## MEMORANDUM

**Document Number:** J-H-NZ0238-011-M-Rev0

**Document Title:** Response to RFI 11 – Fast Track Approvals Application FTA-2507-1089

Figure 1: Hydraulic conductivity data summary.

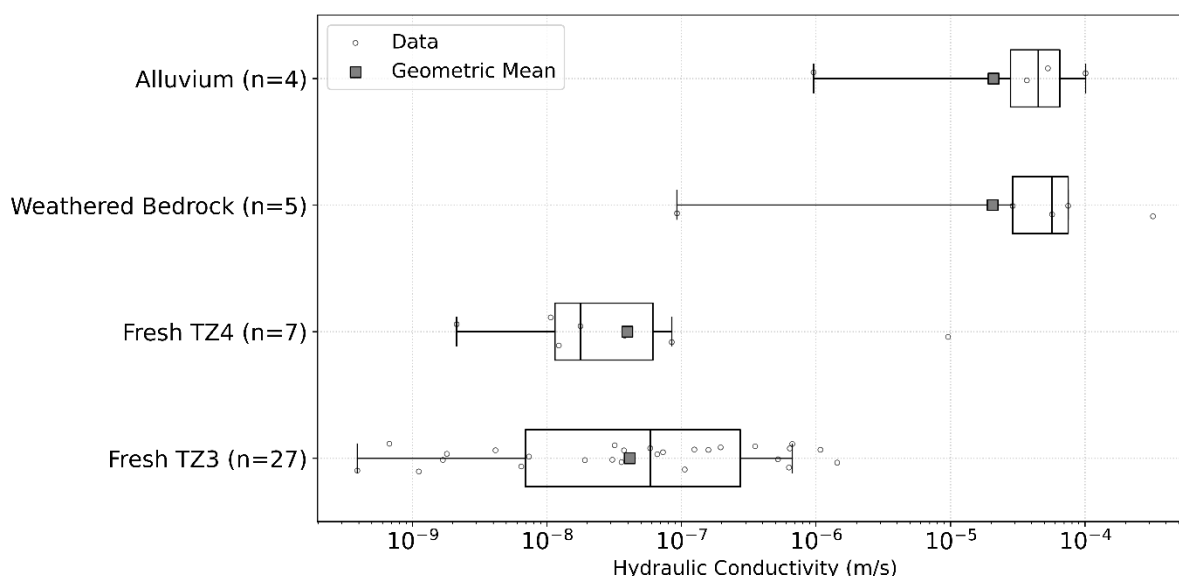
- Groundwater flow from topographic highs (e.g., ridges) to lows (e.g., Shepherds Creek valley bottom), and down valley towards SC01. Unrecovered seepage is generally expected to be consistent with this flow pattern.
- Low hydraulic conductivity (K) Fresh (schist) Bedrock with average<sup>2</sup>  $K=4 \times 10^{-8}$  m/s (Figure 1). Data indicate is little difference in K between fresh TZ3 and TZ4 schist bedrock on average.
- At shallower depths, the fresh bedrock is overlain by higher K Weathered Bedrock on the valley sides and Alluvium in the valley centre, both with average  $K=5 \times 10^{-5}$  m/s (Figure 1). Weathered Bedrock is typically thin in the valley centre/bottom.

These higher K units (Alluvium and Weathered Bedrock) are the preferential pathways for seepage migration that require management.

Overall, I consider the level of baseline physical hydrogeological information is appropriate to sufficiently understand likely seepage pathways and inform conceptual design of seepage control and interception measures. Further investigations will be required to inform detailed design of seepage collection and interception systems which is a standard approach at detailed design.

Figure A1: Bedrock Gap and depth to bedrock.

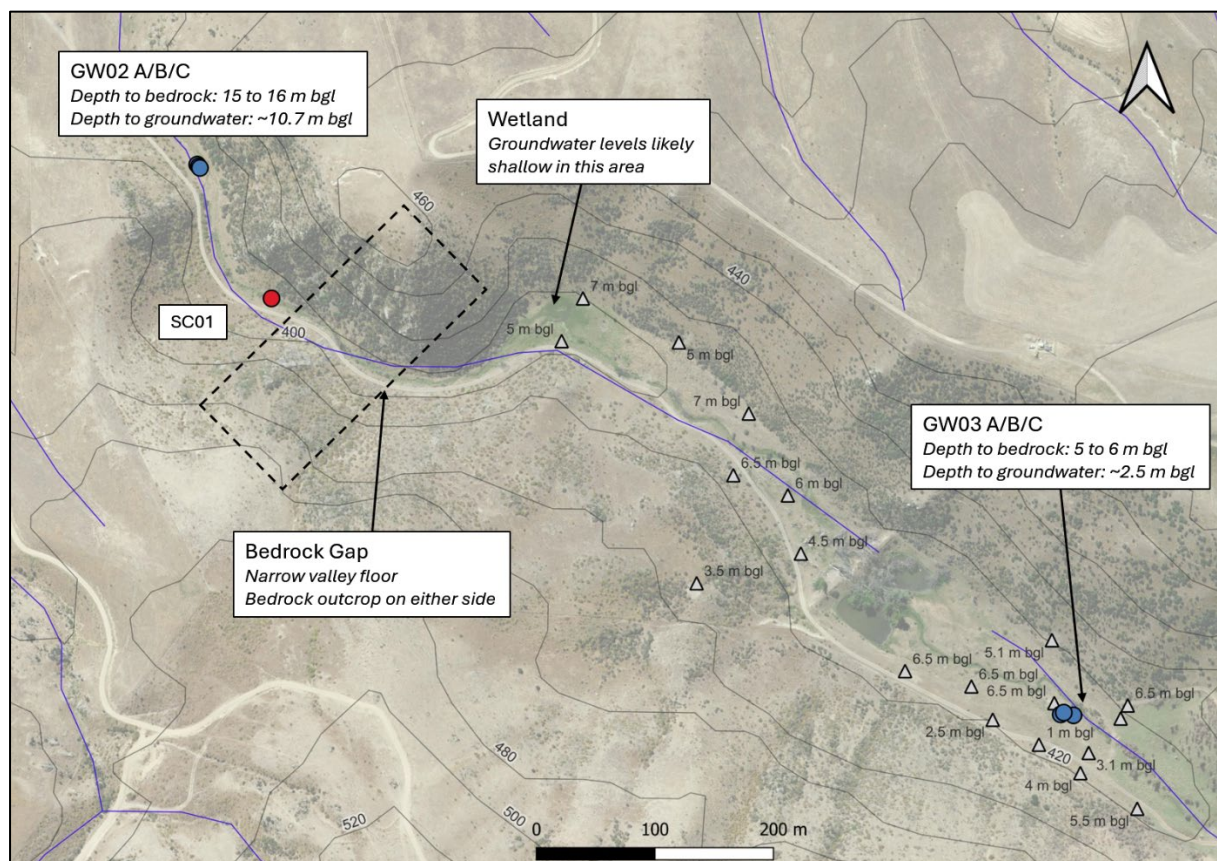
Submitters have noted (as per HGG, 2026a) the (i) relatively deep bedrock surface and (ii) the downwards vertical hydraulic gradient at GW02. This is explained by the uplands of the Shepherds Creek valley transitioning into the main valley of the Lindis and Clutha rivers with bedrock depth increasing from GW02 towards the Lindis River (approximately north to north-west in Figure A1). The location of GW02 was selected as the area as close to the Bedrock Gap as possible that avoided the need for additional permits for drilling closer to the creek channel. Figure A1 shows the depth to bedrock data from test pits (EGL, 2025) and recent drilling described in HGG (2026a). Data presented clearly shows the depth to bedrock upstream of the Bedrock Gap to be in the range of 5 to 7 m below ground level (bgl). Also clear from Figure A1 is the nature of the Bedrock Gap where the valley bottom narrows substantially and exposed bedrock outcrops on the valley sides. At MW03, the valley bottom is approximately 75 m wide while at the Bedrock Gap, it is approximately 10 to 15 m wide. In my opinion, such conditions suggest an even shallower depth to bedrock at this location and data upstream show, or at the very least, a similar depth to bedrock (i.e., 5 to 7 m bgl).

In addition, the narrowing of the valley is likely to cause upwelling of groundwater (or at least shallower groundwater levels) as the alluvium cross-sectional area reduces (assuming thickness remains the same or lowers). For example, the cross-sectional area of the alluvial aquifer perpendicular to down valley flow at GW03 is approximately 530 m<sup>2</sup> (assuming an average thickness of 7 m and width of 75 m) while at the Bedrock Gap, the cross-sectional area is be approximately 100 m<sup>2</sup> (assuming the same aquifer thickness and width of 15 m) or less if thickness is lower than at GW03 (which I consider likely). This fivefold (or more) reduction in area would act to raise the groundwater levels at the Bedrock Gap compared to GW03, resulting in a greater propensity for groundwater discharge to Shepherds Creek at that this narrowing of the valley. I would therefore expect vertical hydraulic gradients in this location to be upwards (as seen at GW03). The presence of the wetland approximately 100 m upstream of the Bedrock Gap is consistent with this interpretation of the groundwater level becoming shallower than seen at GW03 (i.e., <2.5 m bgl).

Any unrecovered seepage that migrates towards SC01 would increase the flow in the groundwater system. For example, I estimate the groundwater flow in the alluvial aquifer at GW03 to be much less than 0.01 L/s<sup>3</sup> and 5% unrecovered seepage from the TSF and Shepherds ELF would be in the region of 0.3 L/s or over an order of magnitude flow in the alluvial aquifer. Such an increase in flow would further increase the propensity of the alluvial aquifer to discharge to Shepherds Creek at the Bedrock Gap. As a result, in my opinion it likely that most unrecovered seepage would report to SC01, as assumed in the Water and Load Balance Models.

Taking this all together, in my opinion the data indicate the Bedrock Gap or anywhere upstream to GW03 A/B/C provide favourable conditions for installation of a high performing contingency seepage interception system (SIS) where:

- It can be positioned to intercept the main groundwater flow path from unrecovered seepage in alluvium and weathered bedrock.
- Valley width is relatively narrow (100 m or less) which will act to focus unrecovered seepage compared to a wider valley that would tend to spread any seepage over a wider lateral extent across the main flow path direction.
- Depth to bedrock is relatively shallow (<10 m deep).
- Depth to groundwater is relatively shallow (<3 m deep) and unlikely to have downwards vertical gradients.

D.04 Condition 26 identifies this general location as one location for implementation of contingency seepage collection measures.
